**SUNDRY NOTICES AND REPORTS ON WELLS**  
*Do not use this form for proposals to drill or to re-enter an abandoned well. Use form 3160-3 (APD) for such proposals.*

8. Well Name and No.  
GAGE COM 1M

BP America is requesting approval to plug and abandon the Dakota formation of the subject well.

**REQUEST FOR VERBAL APPROVAL: Gage Com 1M API: 30-045-32075**

**Cage Com IM**  
MV/DK  
3004532075  
Unit J - Sec 20 - T30N - R10W  
San Juan

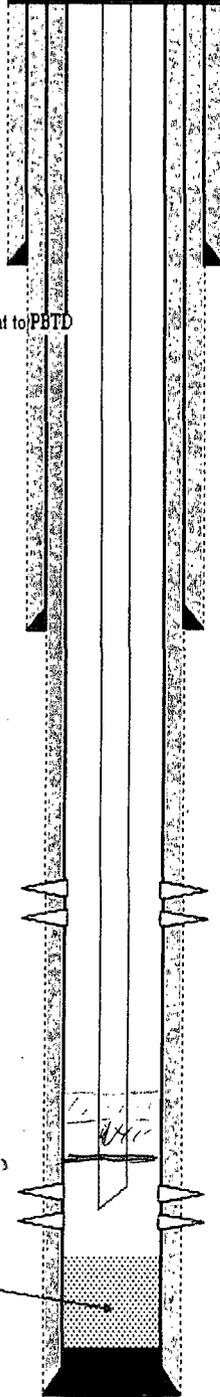
We performed a sand treatment for both MV and DK horizons of the subject well. The 2nd stage was to set a cement retainer (at 7080ft) above DK perfs and treat the MV which was done successfully.

However, we have a fish (9' stick-up and one joint of tubing, a bit sub and 3 7/8" taper mill) in the hole and we have been trying to retrieve for almost 2 weeks now. The top of the fish is at 7,053 ft. We still intend to continue to try to fish it out, however if we are unsuccessful, the plan would be to P&A the Dakota. Therefore, we are requesting approval to plug and abandon the Dakota formation.

Our intention is to pull the fish and return the well back to production and continue to produce from both zones. This plan and approval would only act as our contingency plan if we cannot retrieve the fish from the hole.

Plug to  
6.45" Approved 1/20/13  
Swm 2 3/8" 4.7# J55 8rd EUE  
EOT @ 7153.94

Fish @ 7053'  
CR @ 7080'  
top perf @ 7105'

Approved By <u>STEPHEN MASON</u>	Title <u>PETROLEUM ENGINEER</u>	Date <u>01/24/2013</u>
Conditions of approval, if any, are attached. Approval of this notice does not warrant or certify that the applicant holds legal or equitable title to those rights in the subject lease which would entitle the applicant to conduct operations thereon.		Office Farmington
